ADDENDUM NO. 3

DATED: November 14, 2024

PROJECT:	WSD New Sr. High School	**DATE:**	11/14/2024
OWNER:	Wynne School District	**PROJECT NO:**	A-23010
TO:	Gary Hoyt Nabholz Construction	**CONTRACT FOR**:	General Construction

1 SECOND FLOOR PLAN - AREA A SOUTH - MECHANICAL

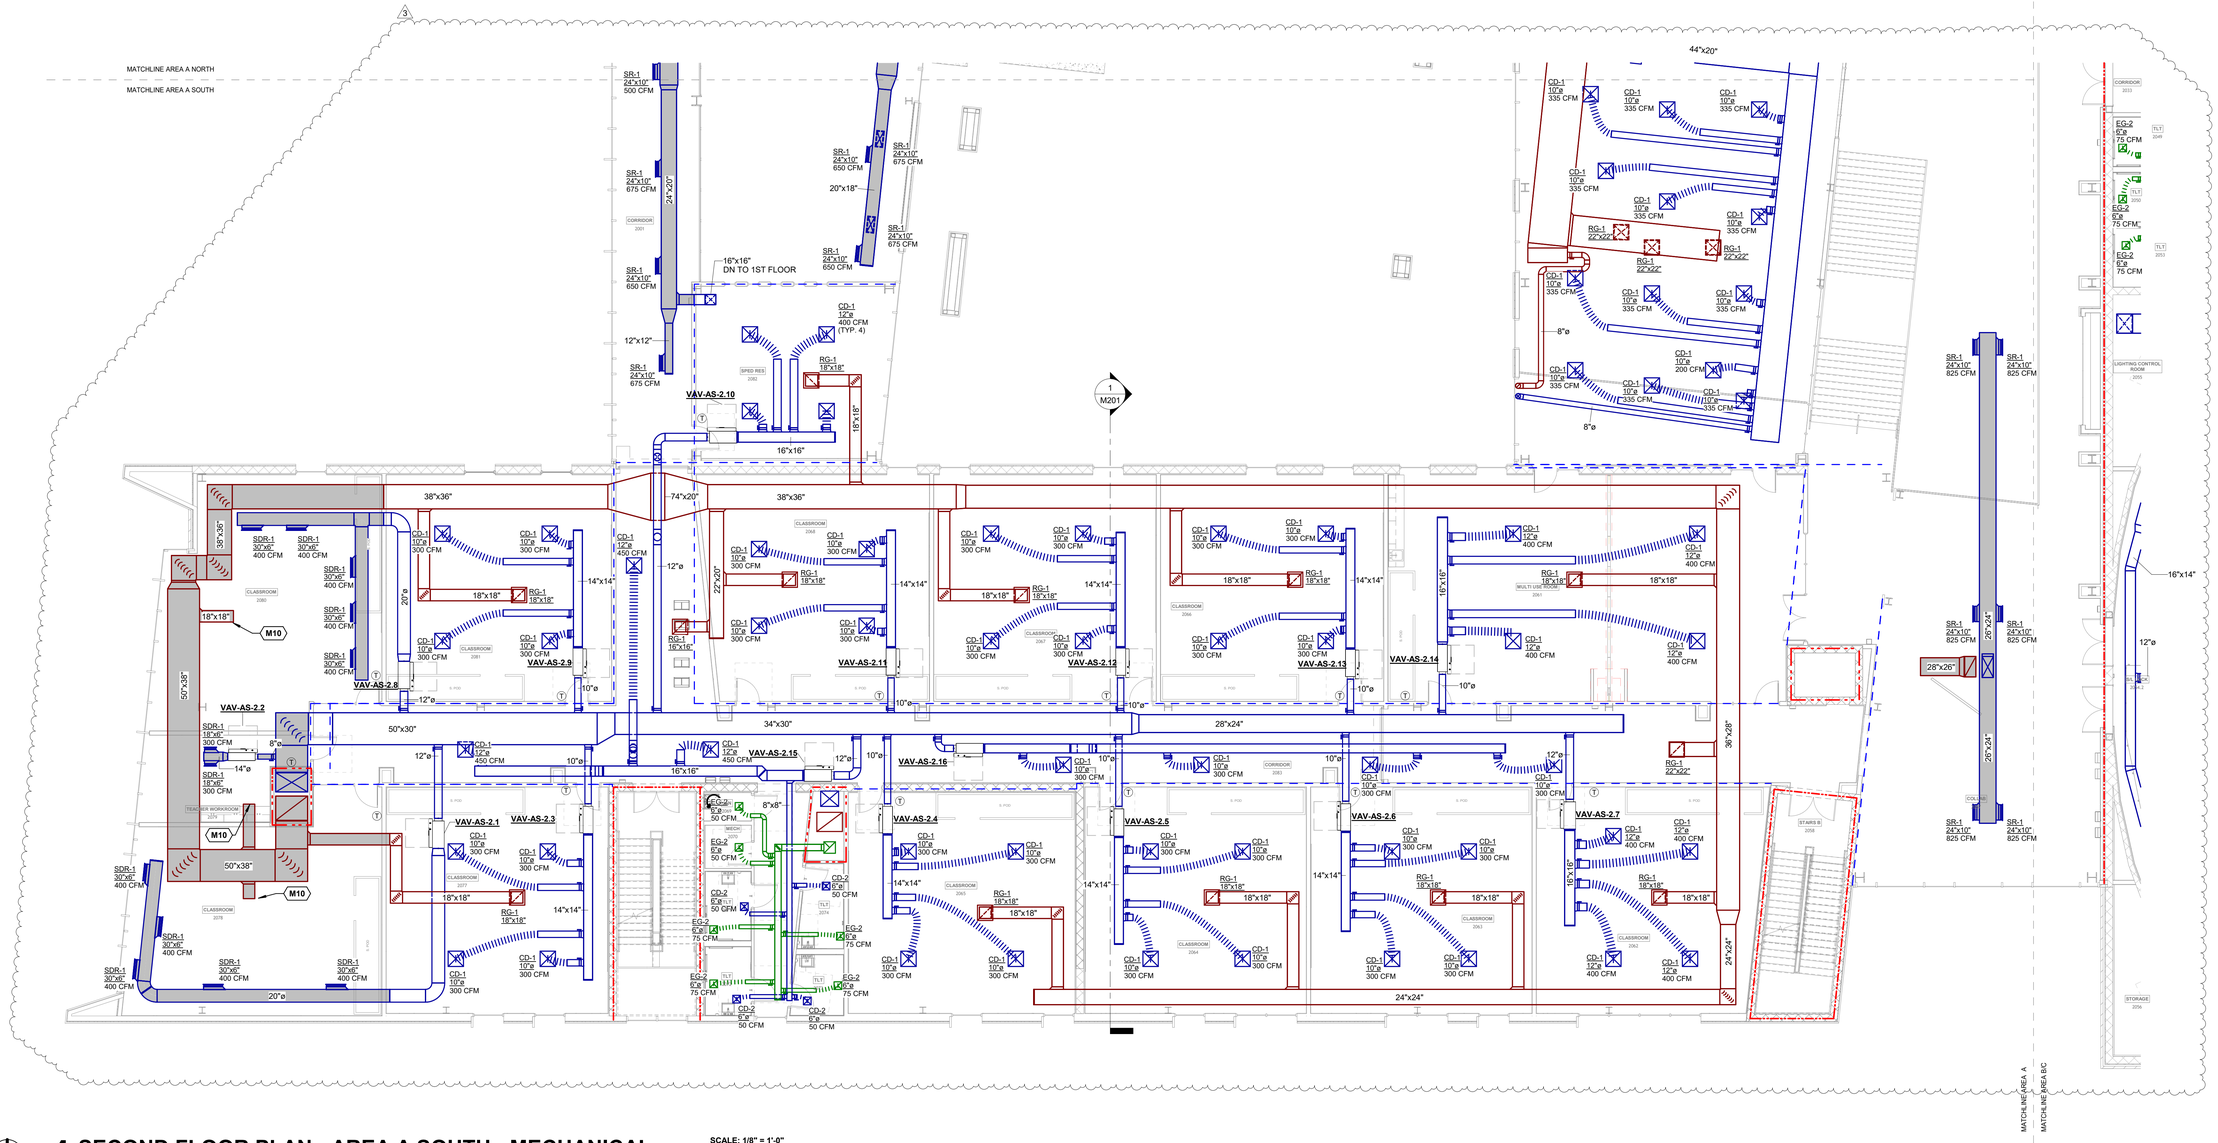
100. Sheet M101.3 FIRST FLOOR PLAN – AREA B - MECHANICAL: Drawing has been updated and revised as indicated on drawing sheet.
101. Sheet M102.2 SECOND FLOOR PLAN – AREA A SOUTH - MECHANICAL: Drawing has been updated and revised as indicated on drawing sheet.

SHEET NUMBER
M103.1

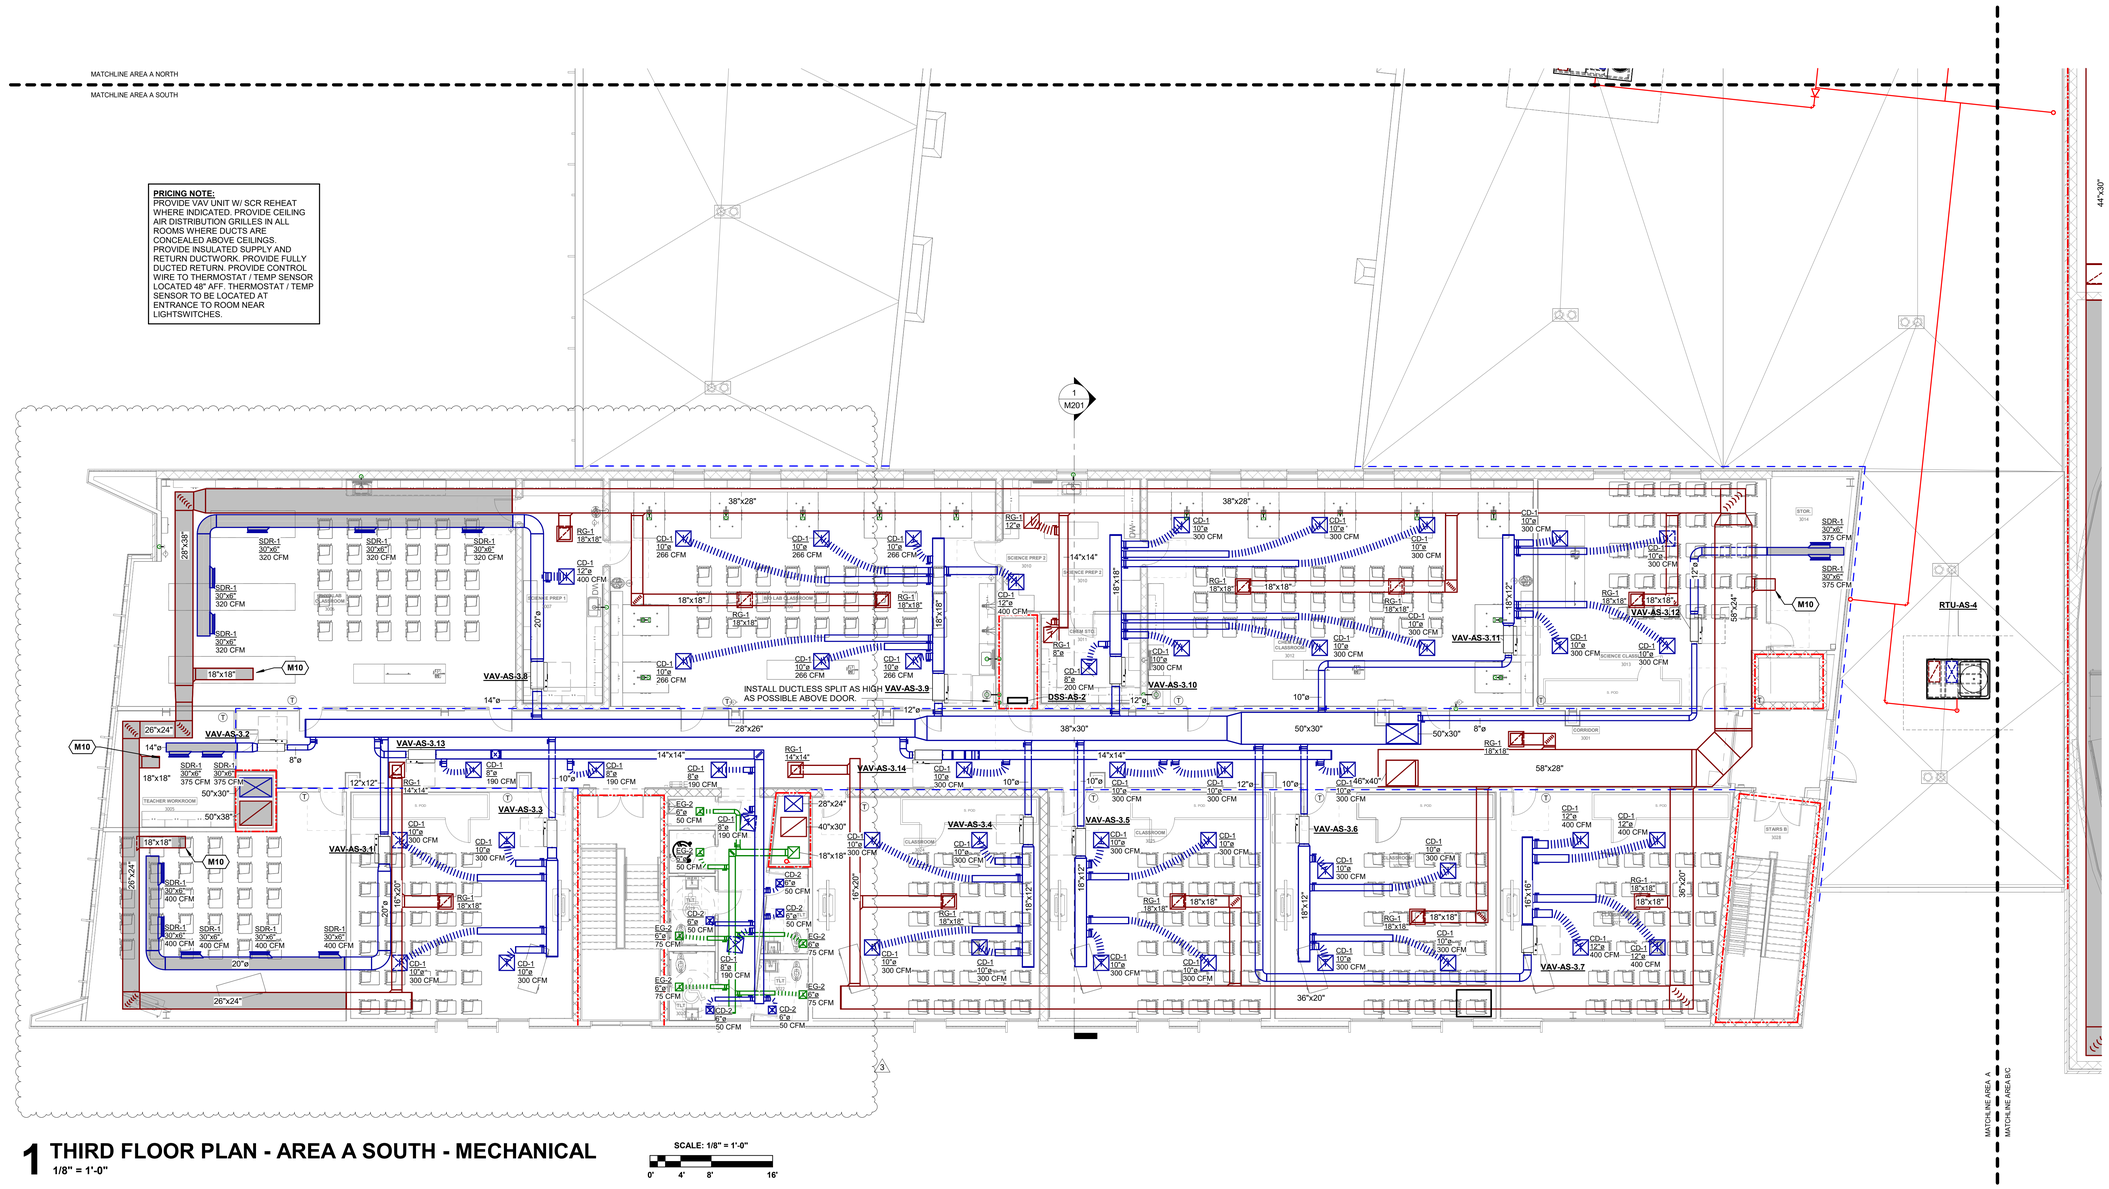
102. Sheet M102.4 SECOND FLOOR PLAN – AREA C - MECHANICAL: Drawing has been updated and revised as indicated on drawing sheet.
103. Sheet M103.1 THIRD FLOOR PLAN – AREA A SOUTH - MECHANICAL: Drawing has been updated and revised as indicated on drawing sheet.

1 THIRD FLOOR PLAN - AREA B - MECHANICAL

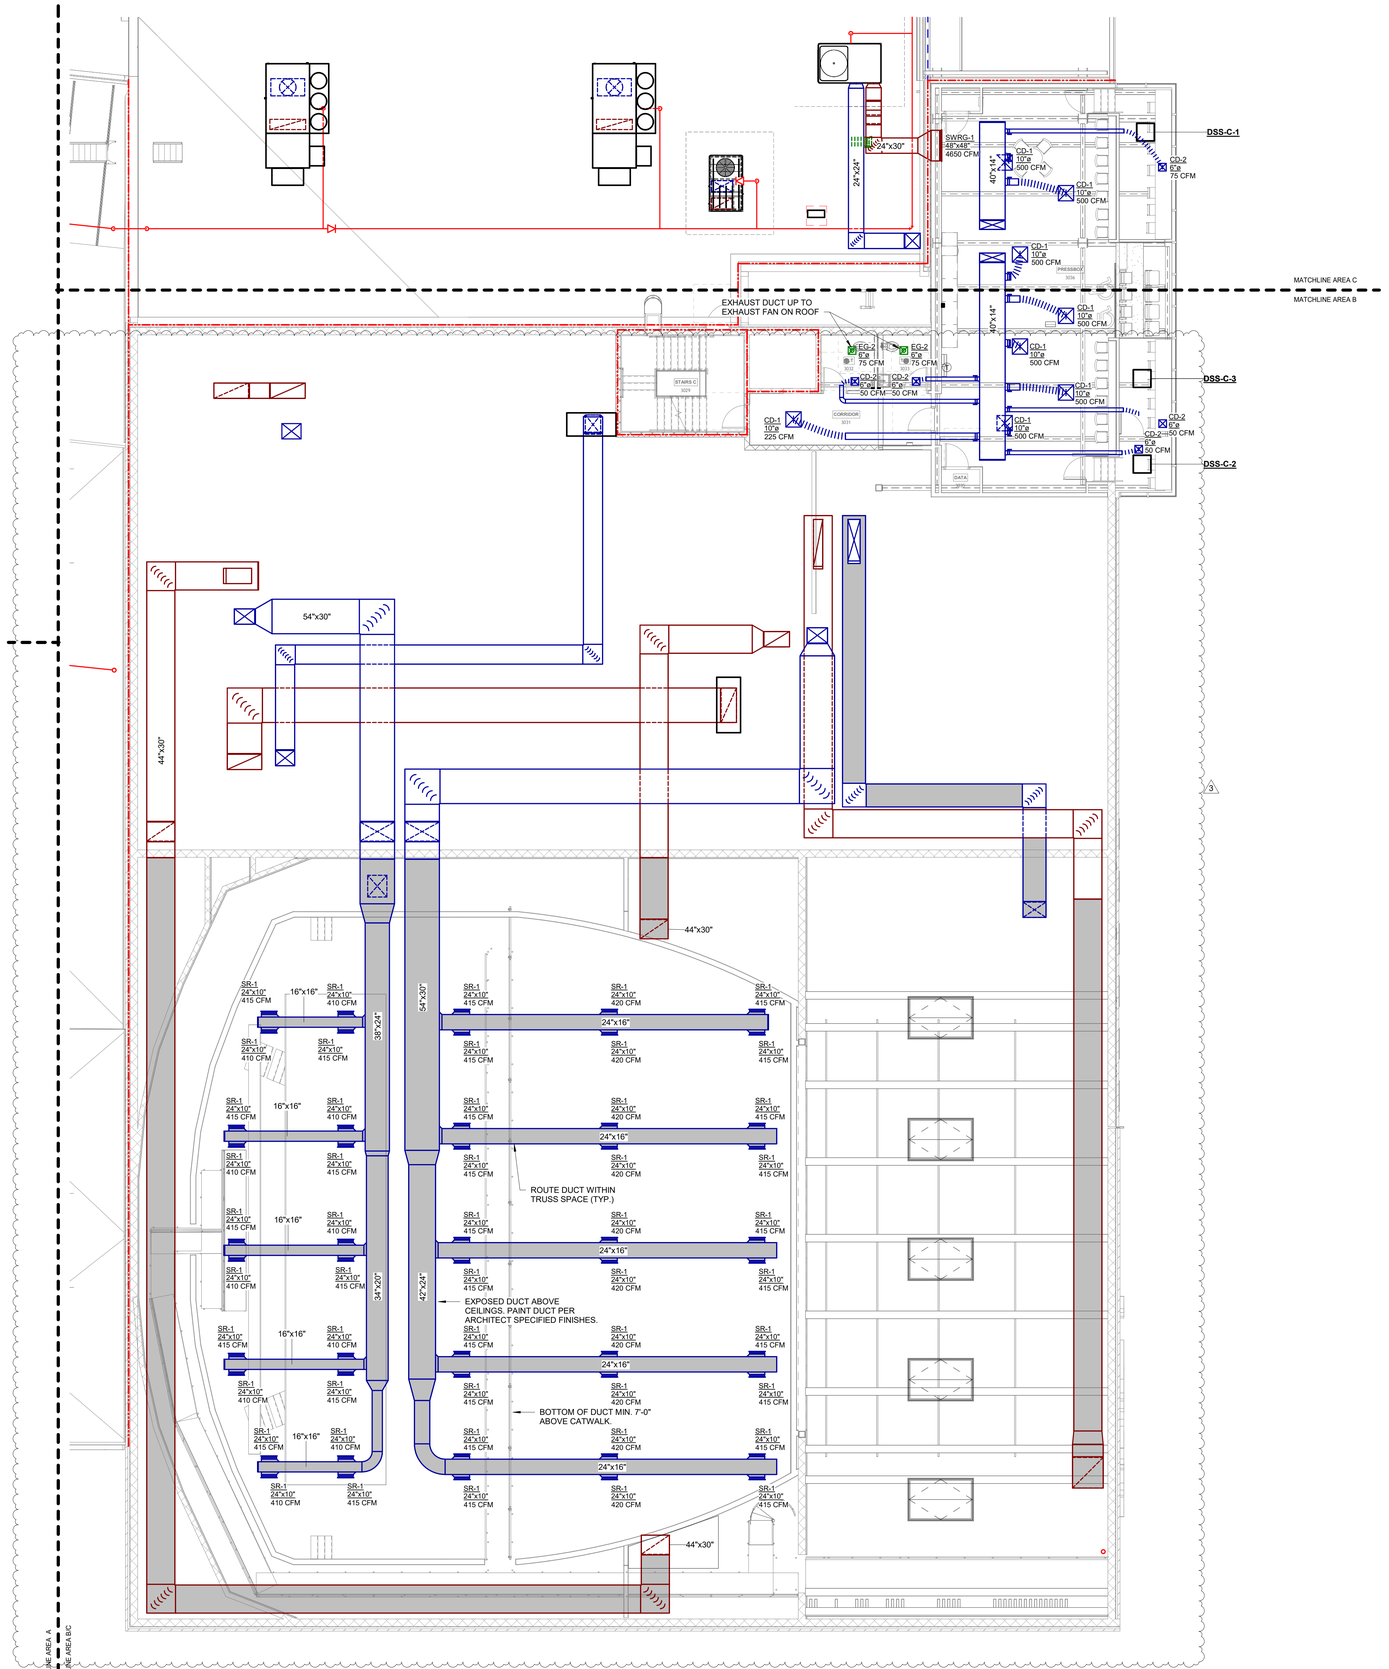
104. Sheet M103.2 THIRD FLOOR PLAN – AREA B - MECHANICAL: Drawing has been updated and revised as indicated on drawing sheet.
105. Sheet M301 ENLARGED PLANS - MECHANICAL: Drawing has been updated and revised as indicated on drawing sheet.

1 FIRST FLOOR PLAN - AREA A SOUTH - DWV

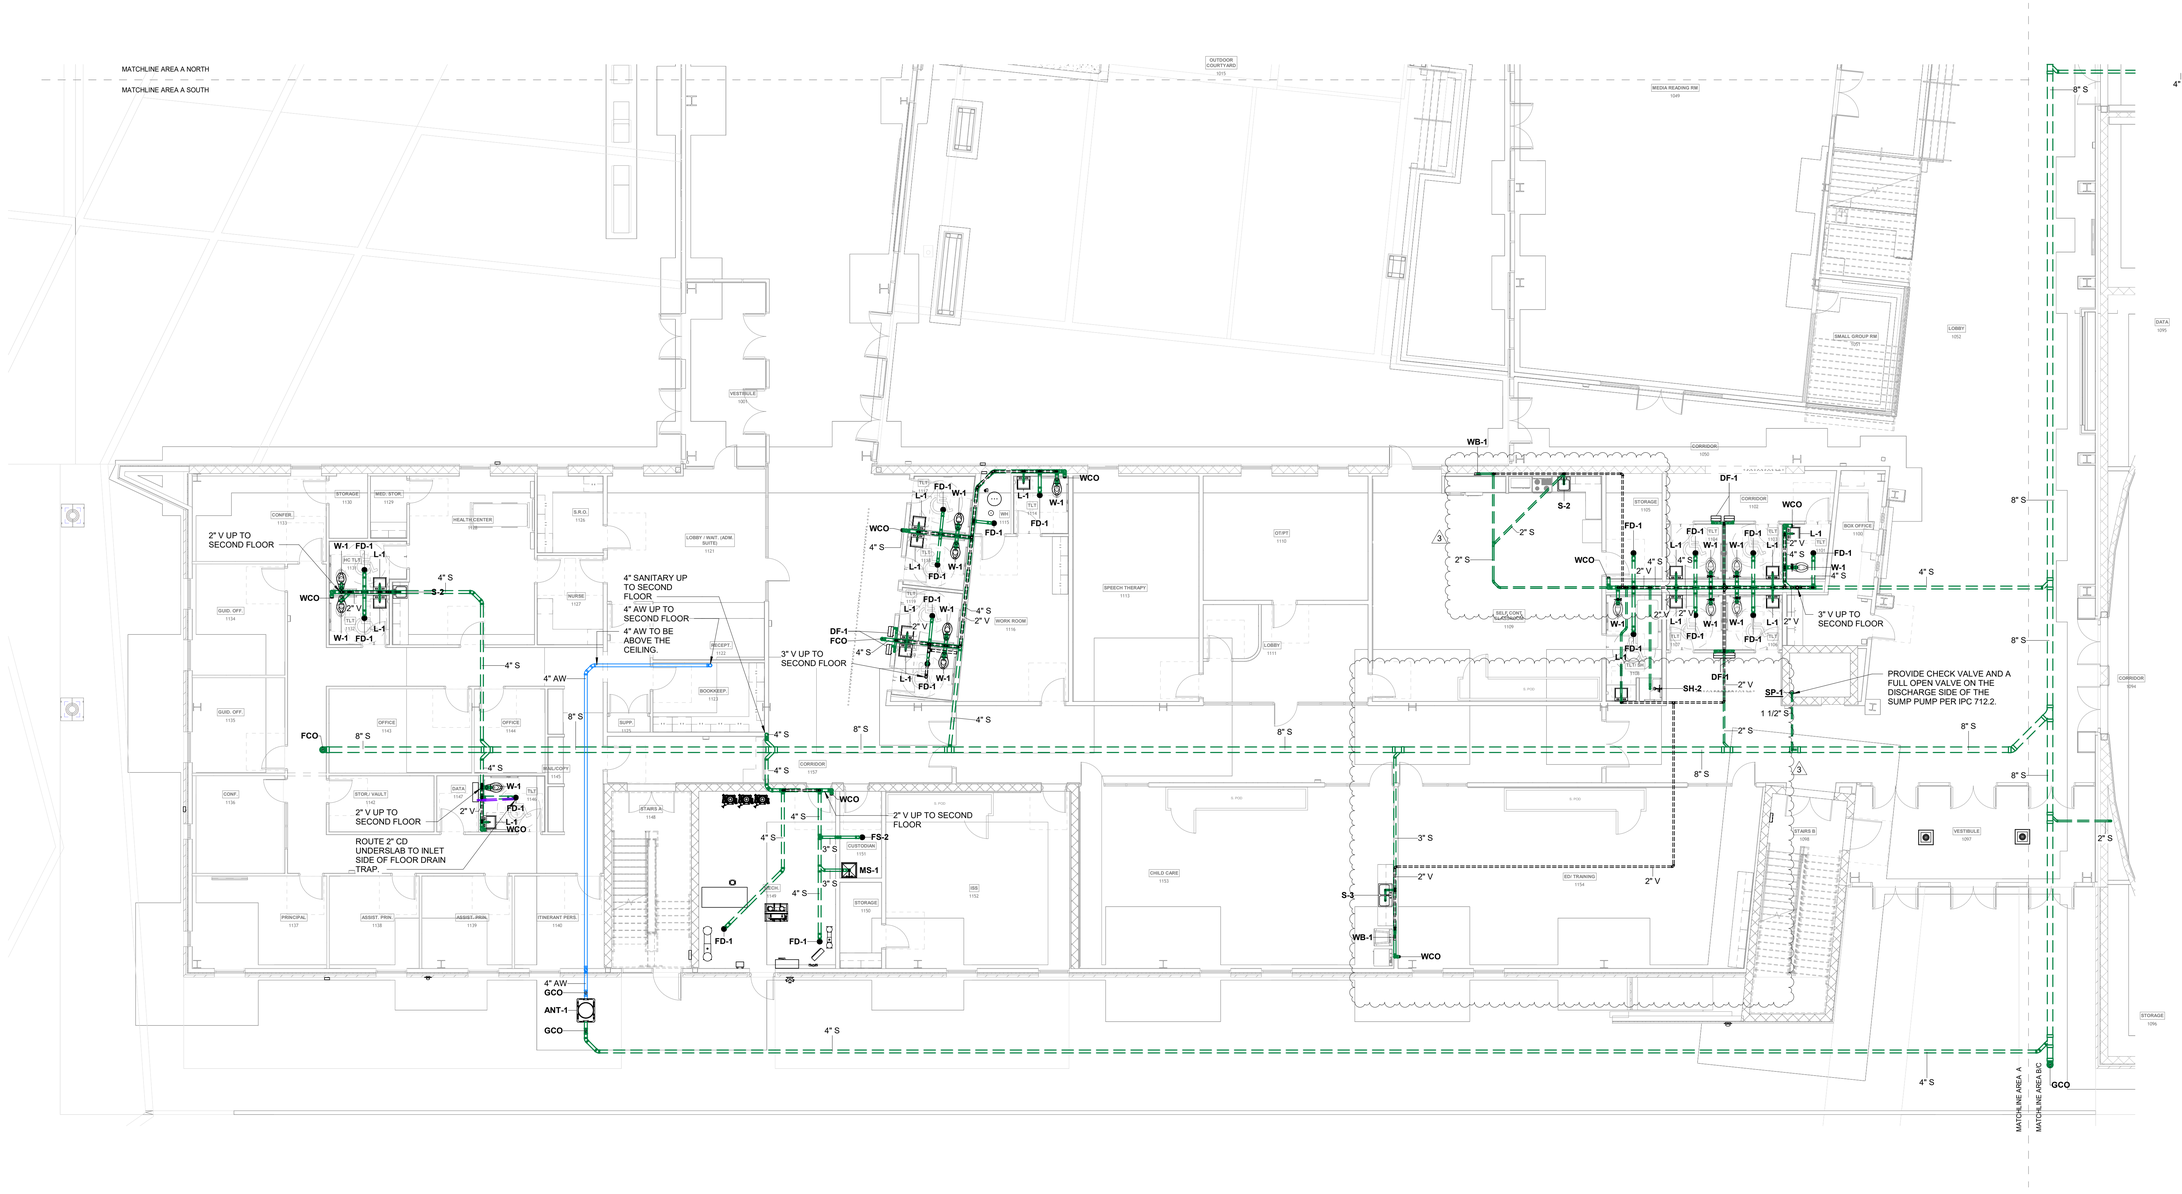
110. Sheet P101.3 FIRST FLOOR PLAN – AREA A SOUTH - DWV: Drawing has been updated and revised as indicated on drawing sheet.
